# THE CITY OF POMONA

Planning Division

This letter is in response to the Draft EIR for the Mr. San Antonio College 2015 Facilities Master Plan Update and Physical Education Projects SEIR. The City of Pomona would request that the traffic study include the following as outlined on Figure 4 Project Trip Distribution:

FIGURE 4  
 Project Trip Distribution

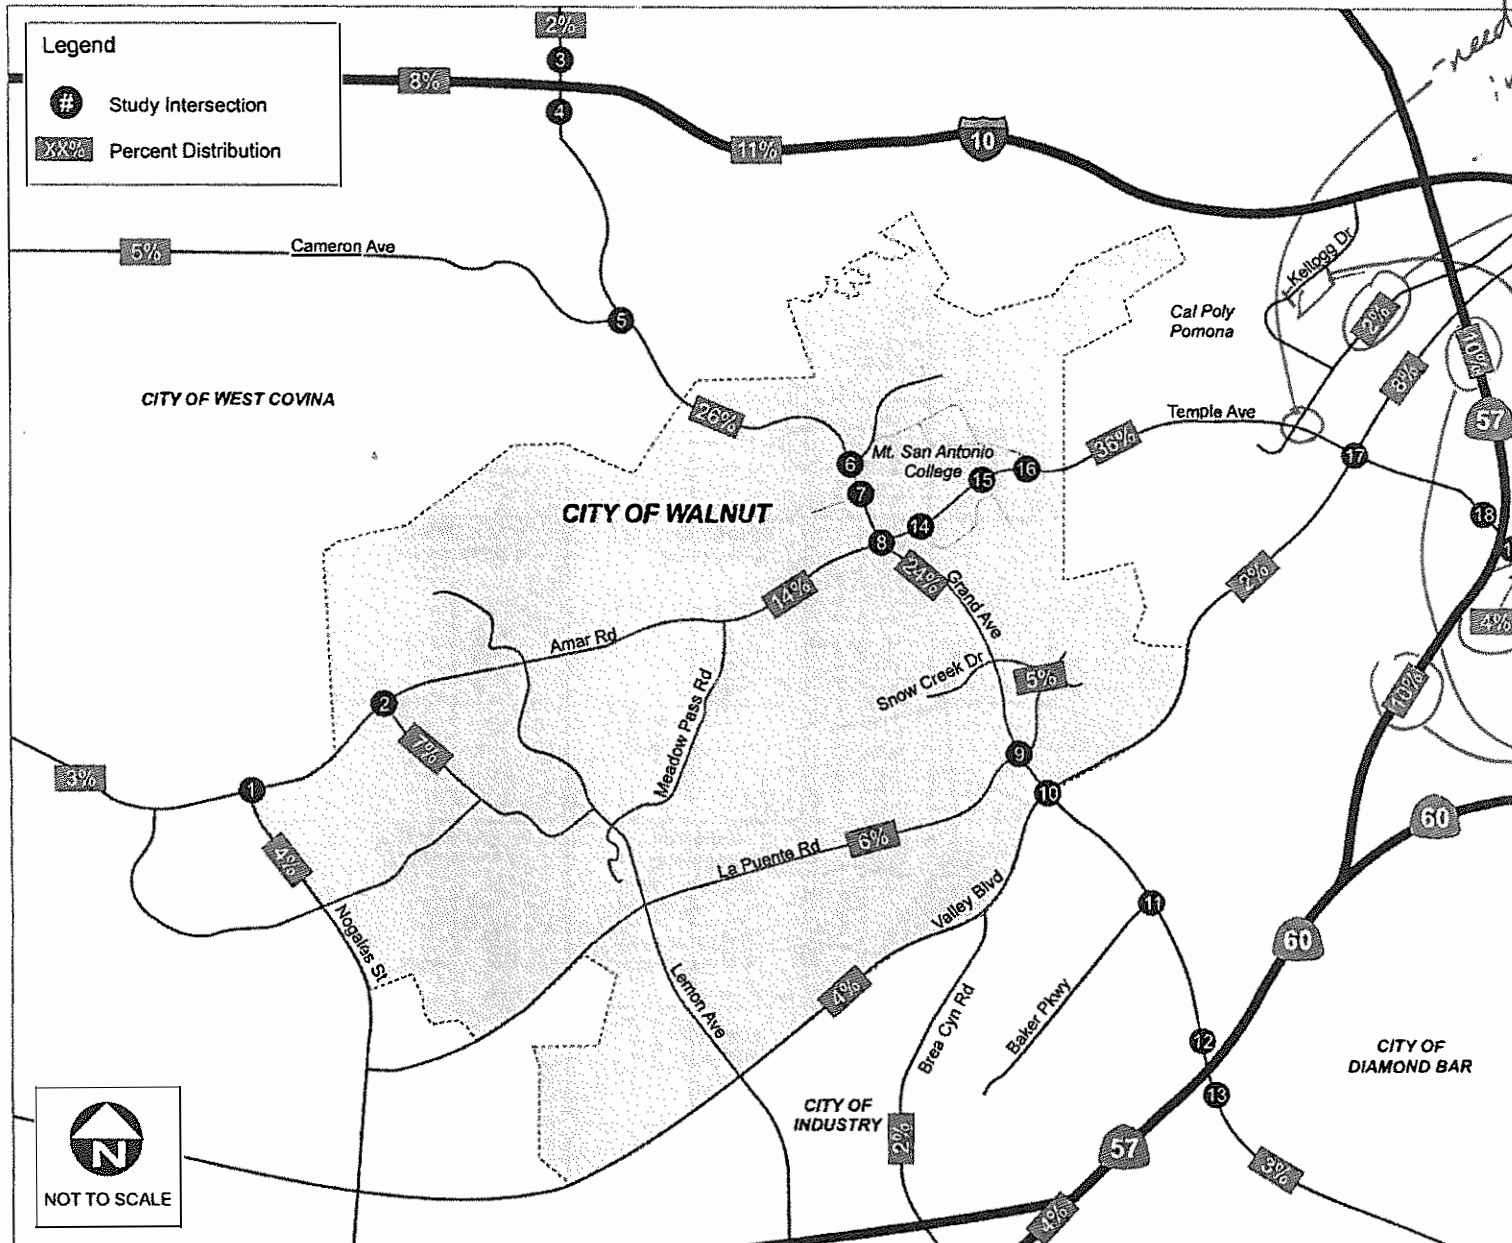
- 1) Should include the intersection of South Campus and Temple Avenue as a study intersection.
- 2) Include a percentage of traffic associated with Kellogg Drive as a high percentage of vehicles come exit 10 Fwy eastbound and continue to Kellogg Dr.
- 3) South Campus volume percentage distribution appears to be too low and not realistic.
- 4) Provide data or methodology to justify the percentage trip distribution along 57 Fwy of 10 percent northbound and 10 percent southbound.
- 5) Justify 4 percent distribution from Temple Ave east of 57 Fwy.

*-need to include S. Campus*

*too low not realistic.*

*high % comes off 10-EB@ Kellogg*

*Questionable (too low)*

*any data to support these %.*
